HISTORIC AND DESIGN REVIEW COMMISSION

HDRC CASE NO: 2018-469
ADDRESS: 3903 N ST MARYS; Located on Tuleta Drive
LEGAL DESCRIPTION:
ZONING: R-6, Public Property
CITY COUNCIL DIST.: 2
APPLICANT: Jeffrey Watson/Alamo Architects
OWNER: San Antonio Zoo/COSA
TYPE OF WORK: Construction of a parking garage
APPLICATION RECEIVED: September 14, 2018
60-DAY REVIEW: November 13, 2018
REQUEST:

Historic and Design Review Commission
Design Review Committee
Report & Recommendation

San Antonio Zoo Parking Garage
Alamo Architects Job No: 2018-27

Building Elevations

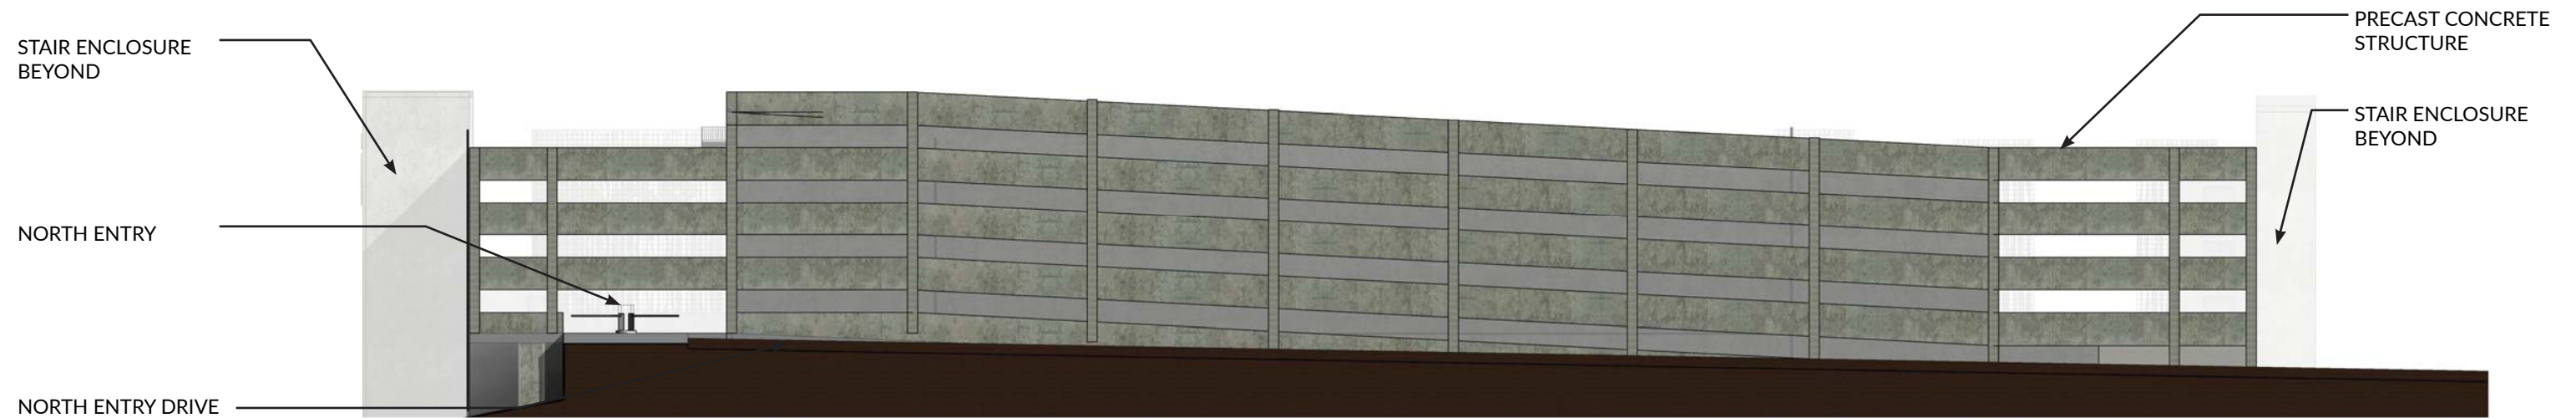
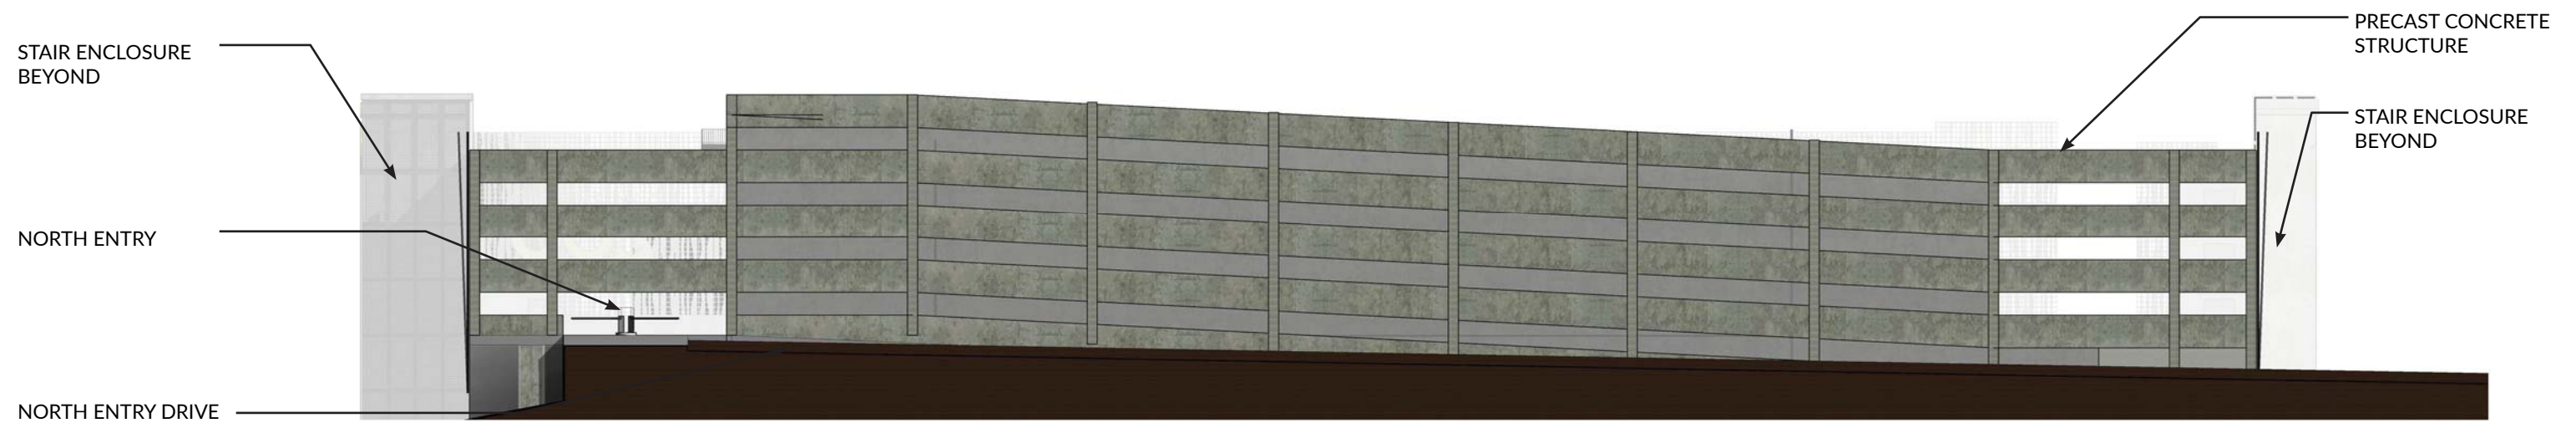
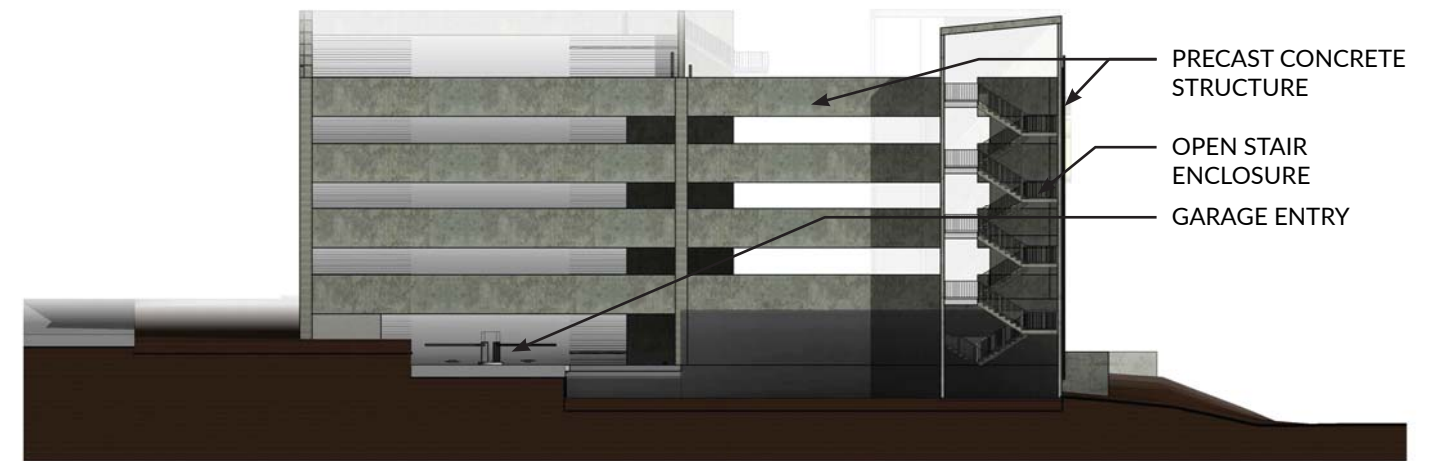
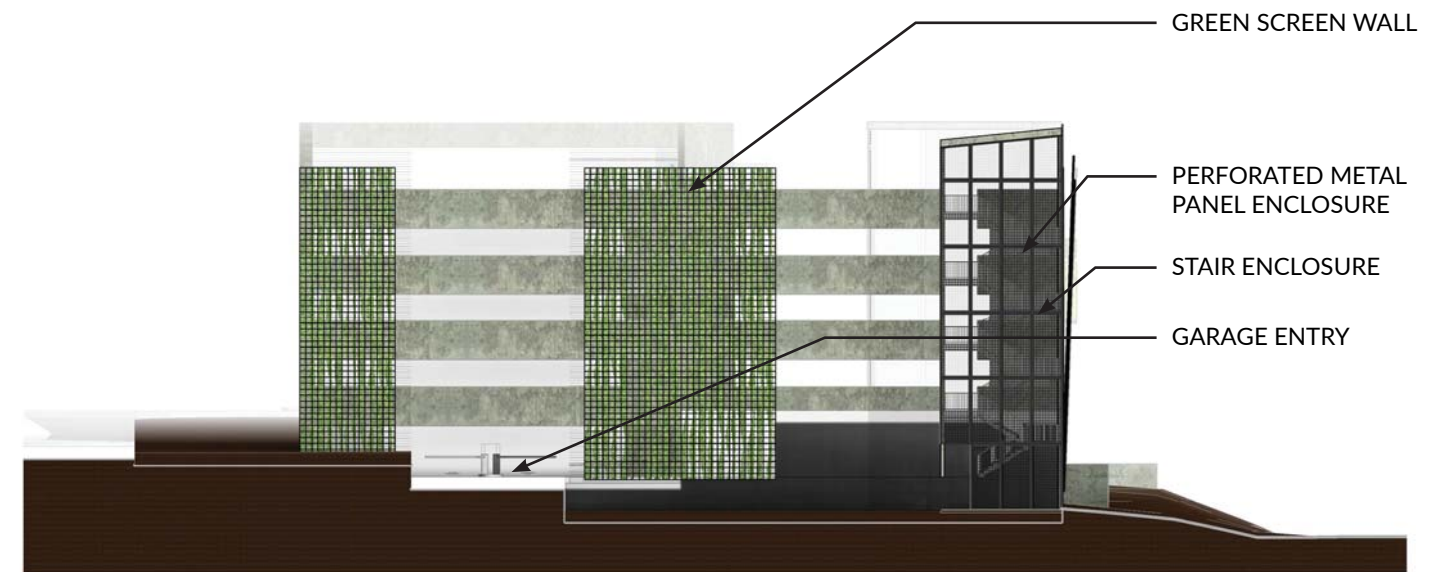
- g. BUILDING DESIGN – The applicant has proposed two options for garage design. These two options feature a similar massing; however, materials vary between the two.

- h. BUILDING DESIGN (Option 1) – Option one features a precast concrete structure, a precast concrete stair enclosure, an exposed foundation wall, green screen walls and landscaping elements.

- i. BUILDING DESIGN (Option 2) – Option two features a precast concrete structure, a stair enclosure with perforated metal panel cladding, an exposed foundation wall, green screen walls (more screening is included in option 2 than option 1) and landscaping elements.

- j. BUILDING DESIGN – Staff finds that option two is the most appropriate given the additional design elements as well as the addition screening elements. Staff finds that the ability to incorporate additional screening into option two would be appropriate.

EF: EAST FACADE MAY NEED ADDITIONAL SCREENING.

JF: ACCOMMODATING GREEN SCREEN FOR NORTH FACADE FOR ADDITIONAL SCREENING
WOULD BE APPROPRIATE.

Staff recommends conceptual approval of design option two for the proposed new parking structure based on findings f through m with the following stipulations:
